Docket Number:	15-BSTD-05
Project Title:	2016 Nonresidential Compliance Manual and Documents
TN #:	205948
Document Title:	Statewide Utility Codes and Standards Team Comments: 2016 Title 24 - Utility Team Comments on NR Compliance Manual - Aug 2015
Description:	N/A
Filer:	System
Organization:	Statewide Utility Codes and Standards Team
Submitter Role:	Public
Submission Date:	8/31/2015 2:51:08 PM
Docketed Date:	8/31/2015

Comments on Draft Title 24 Nonresidential Compliance Manual

2016 CALIFORNIA BUILDING ENERGY EFFICIENCY STANDARDS

California Utilities Statewide Codes and Standards Team

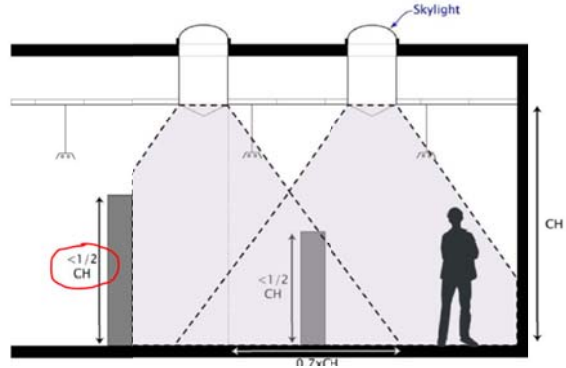
3-35	6. Furred	6. Furred walls: Are a specialty wall component, commonly applied to a mass wall type. See	Revise for accuracy of definition.	Brian Selby

Page	Section/ Paragraph	Suggested Revision	Comments	Commenter
	walls:	Figure 3-4 below. The Reference Appendix JA4 Table 4.3.5, 4.3.6 or other masonry tables list alternative walls. Additional continuous insulation layers are selected from Reference Appendix JA4 Table 4.3.13 and calculated using either Equation 4-1 or 4-4 from the JA4. The effective R-value of the furred component depends upon the framing thickness, and type and insulation level <u>according to the appropriate table in the JA4.3. To determine the overall U-factor for the mass wall and furred wall component assembly, use Equation 4-3 from the JA4 for double wall assemblies.</u>		
3-36	Example 3-10	Question An 8 inches (20 cm) medium-weight concrete block wall with uninsulated cores has <u>a layer of 1 inch (25 mm) thick exterior polystyrene continuous</u> insulation with an R-value of R-5. What is the U-factor for this assembly?	Revise question for clarity.	Brian Selby

Figure 4-13 — Building Status Flowchart

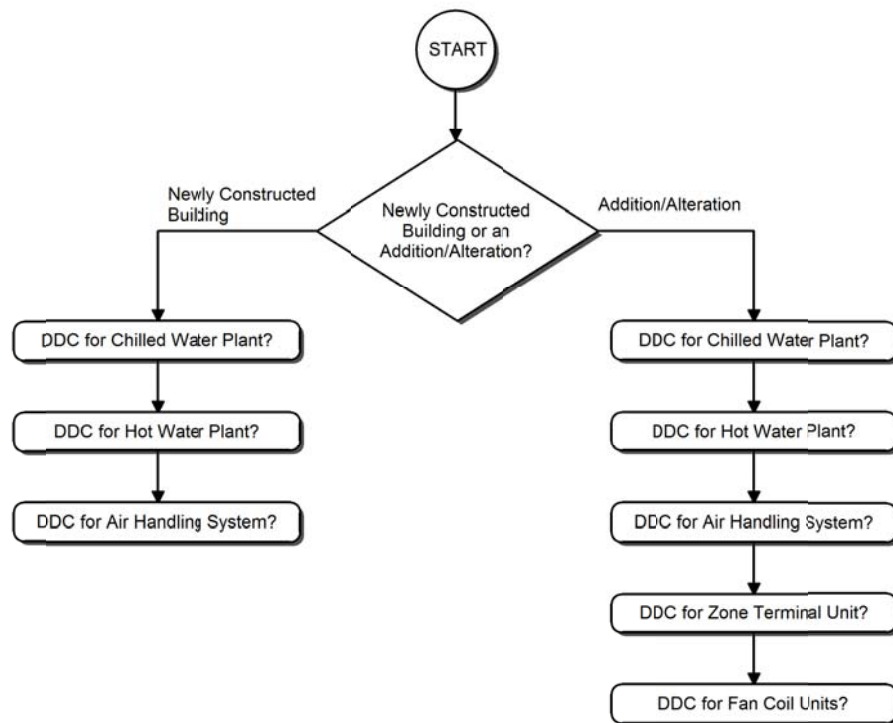
4-90	Table 4-17	Individual systems <u>with design heating or cooling capacity of 300 kBtu/h with fan system bhp of 10 hp (7.45 kW)</u> and larger and supplying more than three zones and more than 75 percent of zones are new	Table entry updated to match adopted Title 24 Standards. The qualifications were modified in the 15-day language.	Scott Bailey
4-90	Insert before Example 4-32	<u>Follow the logic flowchart in Figure 4-13, Building Status Flowchart to determine if a DDC system is required for newly constructed buildings or for additions or alterations to buildings. The Building Status Flowchart will indicate which equipment flowchart (Figure 4-14 through Figure 4-18) should be used for each type of HVAC equipment that will be installed in the building.</u> <u>The logic of the equipment flowcharts will indicate whether DDC is required for the building, how DDC should be applied to the</u>	Insert flow charts (Figures 4-13 through Figure 4-18) and accompanying text to help explain when DDC is required to the zone. See Appendix D for larger versions of Figure 4-13 through Figure 4-18	Scott Bailey

The Statewide Utility Team recommends adding the following flow charts to Chapter 4 of the Compliance Manual to help explain when DDC is required to the zone level.
